Planning and Land Use Committee Report

Subject: **Development Permit Application #000347 for 845 Yates Street**
Application to remove existing tile on the east elevation and apply a painted mural.

845 Yates Street
Development Permit #000347

**5098.10 – 845 Yates Street
Adhered Stone and Tile Review**

2. PROPOSED EAST ELEVATION

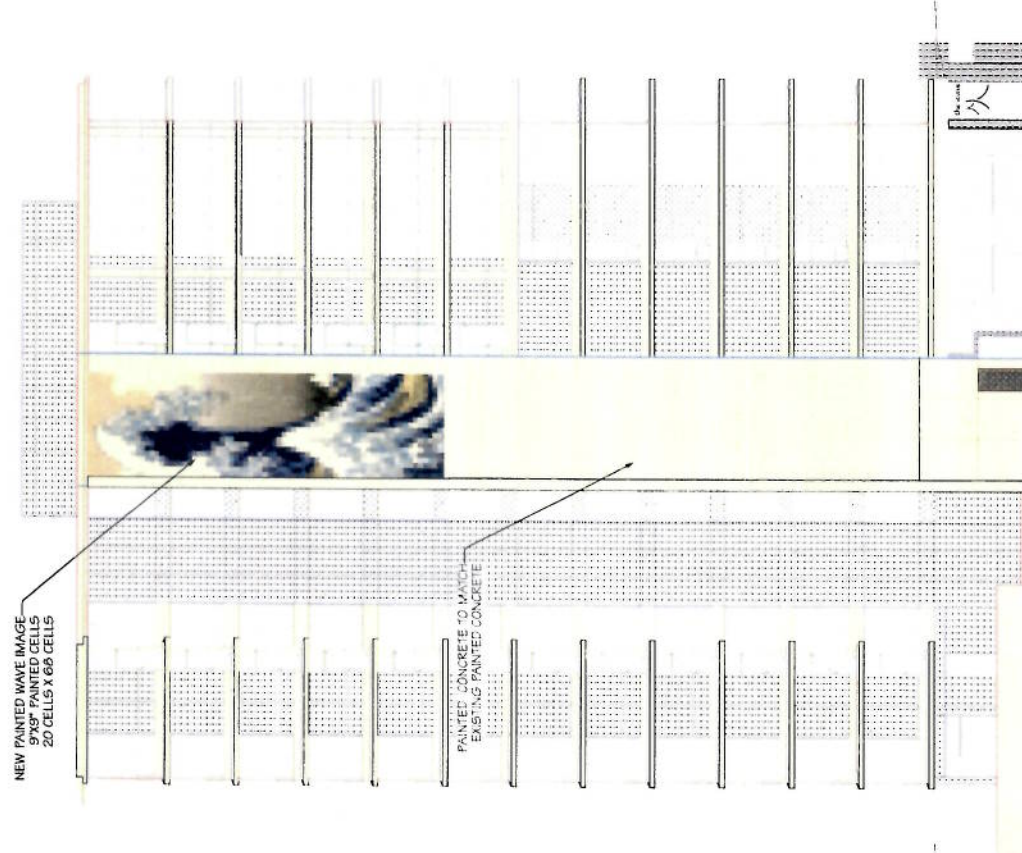
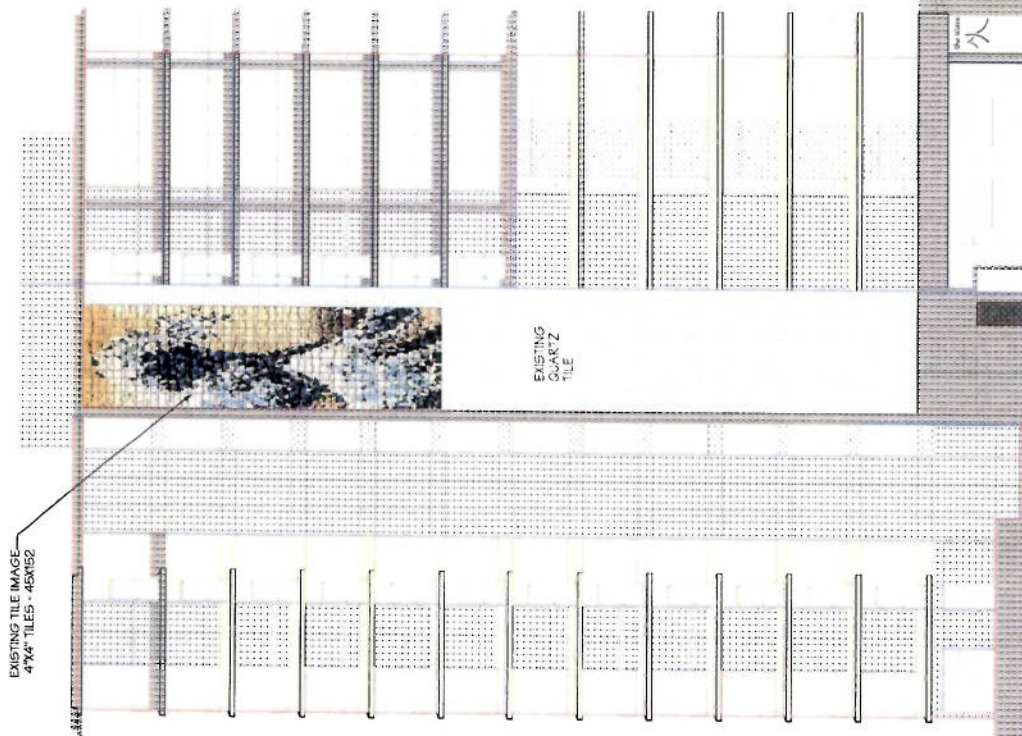
The proposed increase in the size of the grid from 4" squares to 9" squares represents an increase in the grid size of 225%. This will have a considerable visual effect resulting from the intended abstract contemporary interpretation of the present design. The proposed increase in grid size in conjunction with an increase in the colour palette would considerably transform the recognizable image. While the intention of the proposed tile replacement is to ensure a durable finished product, the proposed increase in the grid size is not necessary to achieve this objective. Staff have discussed the possibility of reducing the grid size with the applicant and the applicant has indicated a strong preference to proceed with the 9" squares as reducing the grid size increases costs.

That Council authorize the Development Permit #000347, subject to the applicant reducing the size of the proposed grid to the satisfaction of the Director of Sustainable Planning and Community Development.

Photo 4

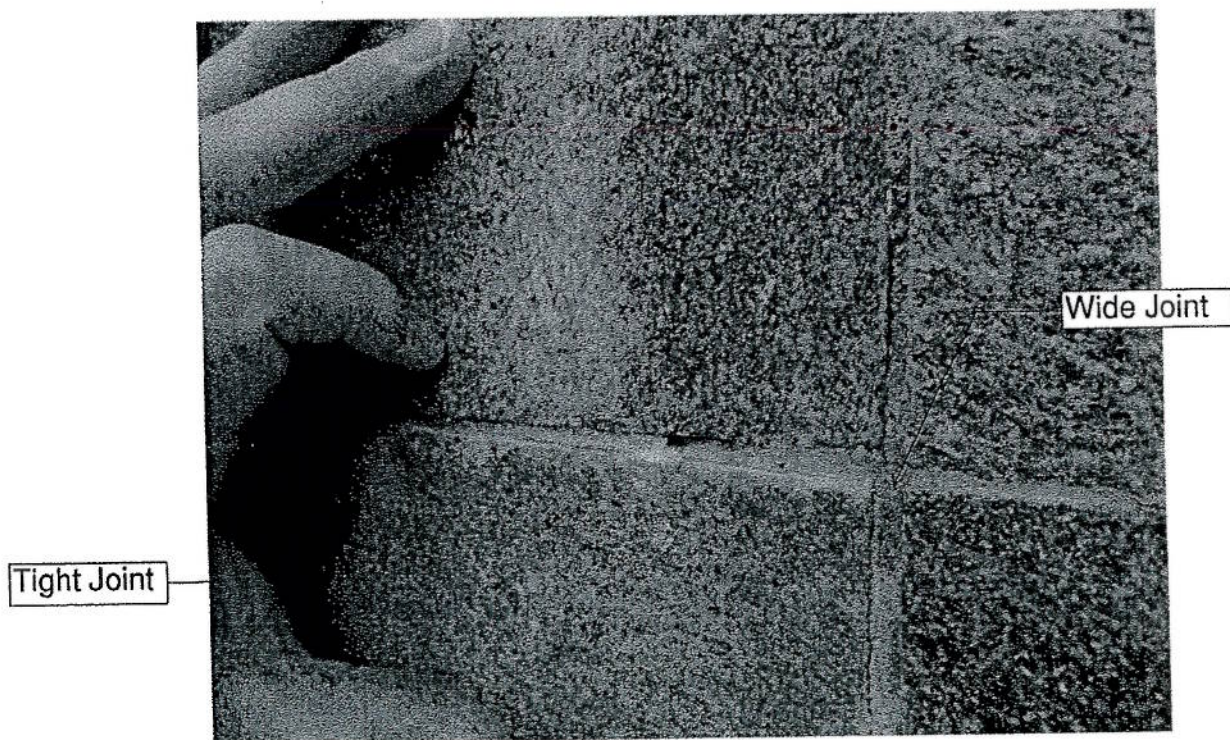
- Joints between stones also varied from tight to approximately 5 mm (Photo 4,5)
- Surface irregularity of stone resulted in offsets and ledges at most joints (Photo 6).

Photo 6

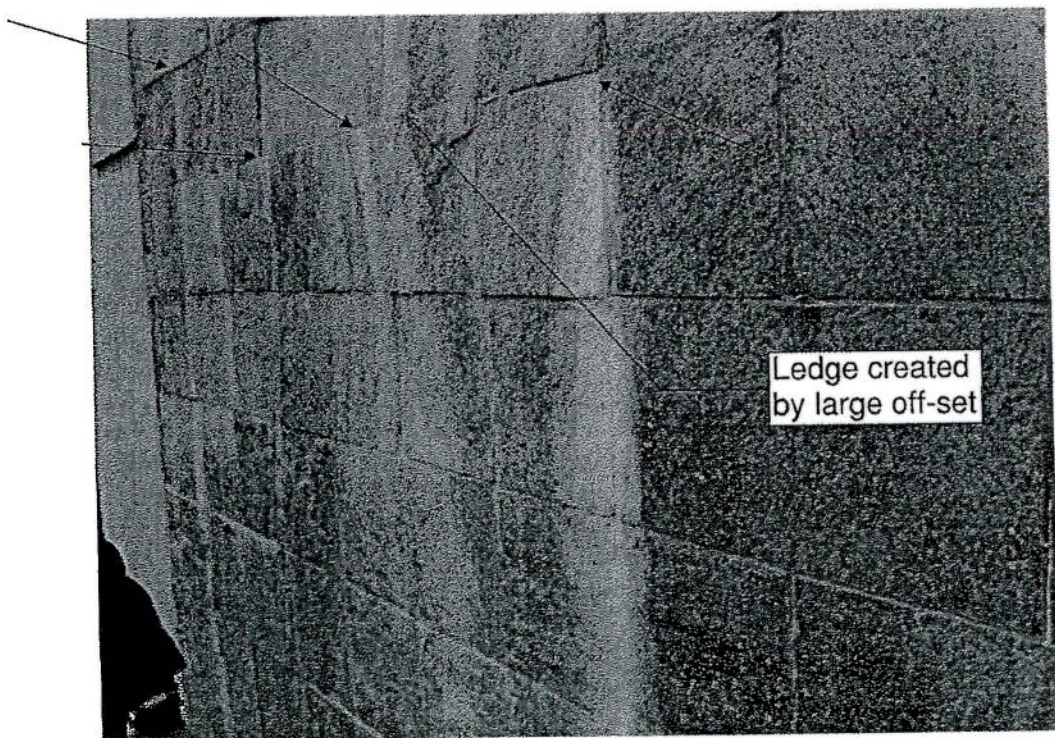
- Cracks and gaps in the grout at stone joints were widespread (Photo 7).
- Efflorescence (white staining) at stone joints was widespread (Photo 6).
- At locations of prior stone removal, observations were made of large areas of undisturbed notched mortar (Photo 8 & 9).

Photo 9

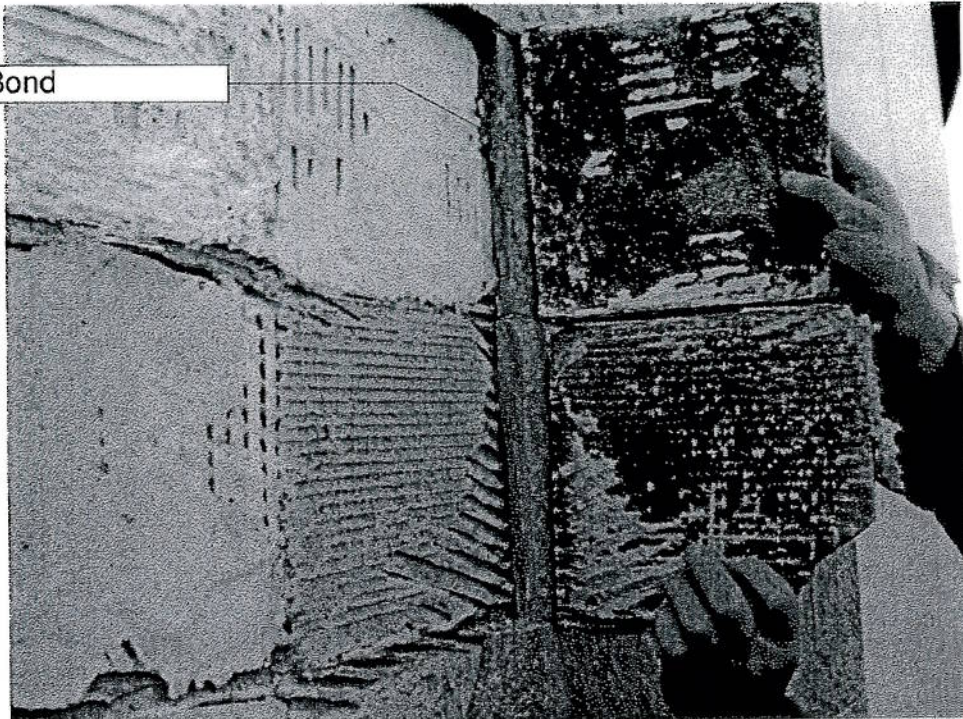
- Removal of "hollow" sounding stone units revealed poor adhesion (Photo 9).
- One removed stone had been scored with a saw (Photo 9).
- A metal control joint was covered with grout (Photo 10 & 11)

Photo 12

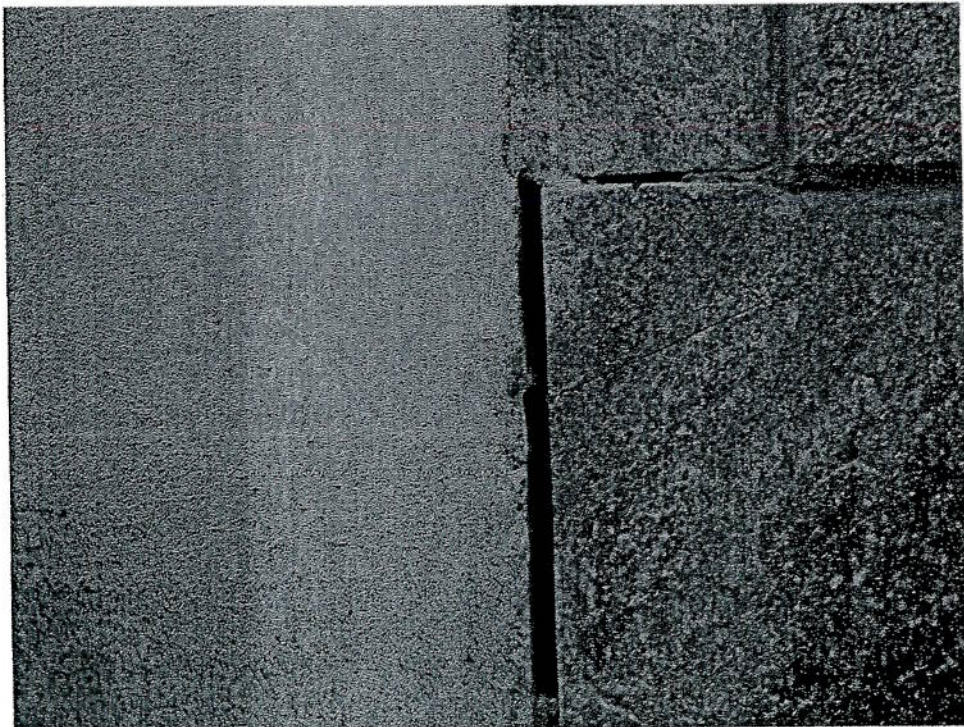
- The joint between the stone and the concrete structure was filled with mortar. The mortar had failed in locations providing an opening for water entry (Photo 12).

Photo 13

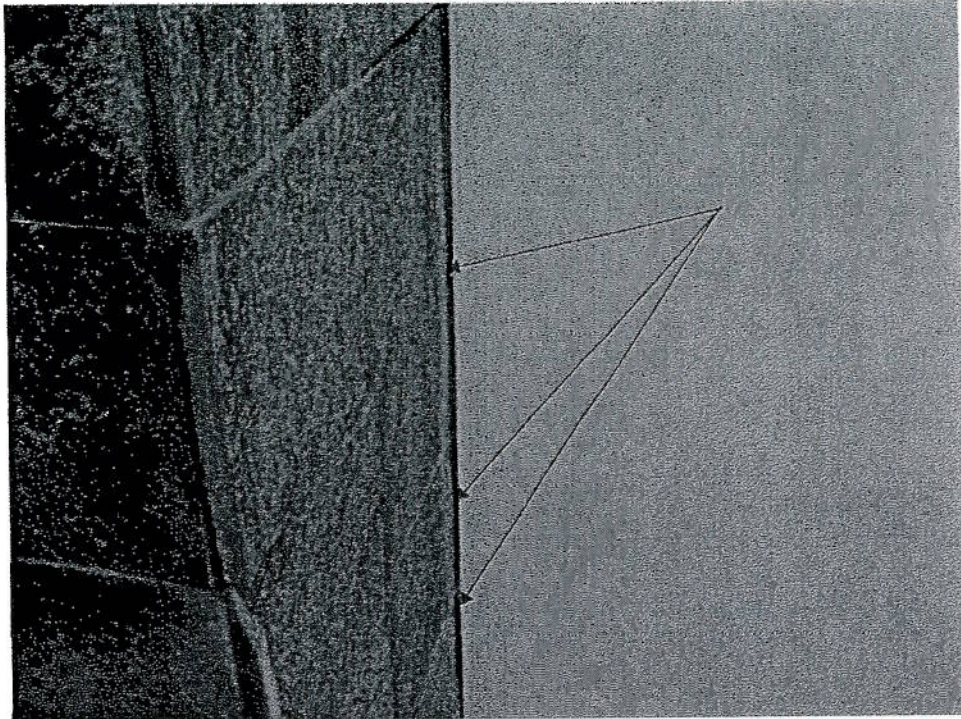
- The joint between the stone and an adjacent cladding panel was filled with mortar. The mortar has failed in locations providing an opening for water entry (Photo 13).

Photo 14

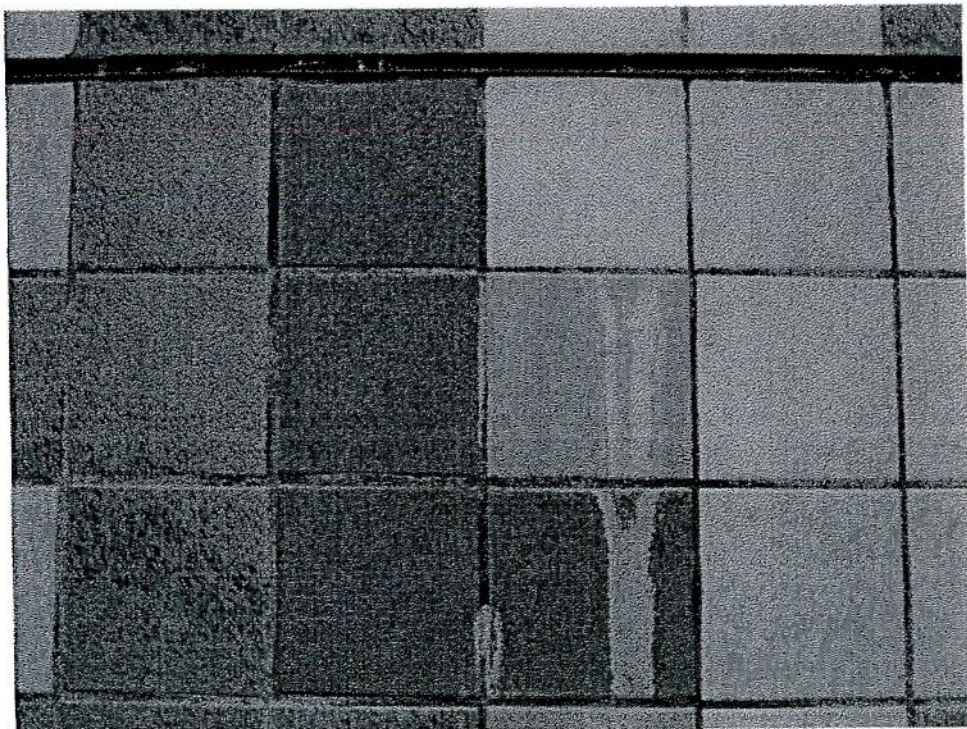
- The tile can be described a "100x 100 mm vitreous through coloured clay tile".
- The width of grout joints in the tile varied from 1/8 to 3/8 of an inch (Photo 14).
- Metal control joints were installed in the tile (Photo 14 & 15).
- Cracks and gaps in the grout between tiles were observed (Photo 14, 16 & 17).

Photo 18

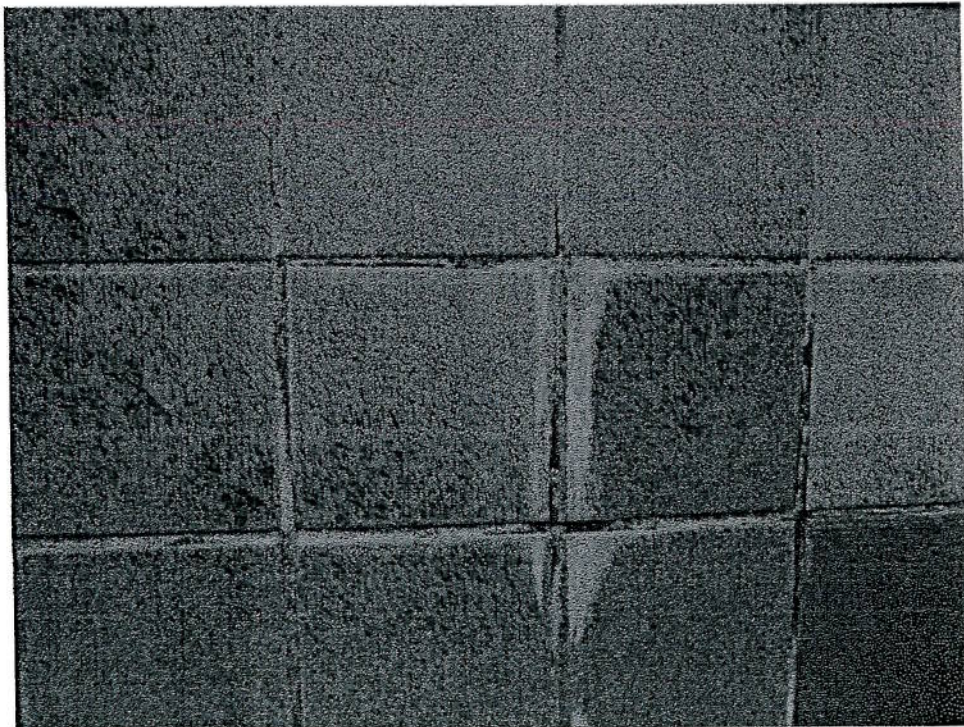
- White staining was observed on the surface of the tiles. The stains originate from joints between tiles (Photo 14 & 18).
- Removal of "hollow" sounding tiles confirmed poor adhesion (Photo 19 & 20).
- The mortar at locations of tile removal appear compressed and in contact with the back of the tiles (Photo 21).
- Tile and concrete interfaces were not sealed to prevent water entry (Photo 22 & 23).
- Removed tiles revealed poor mortar adhesion (Photo 24).
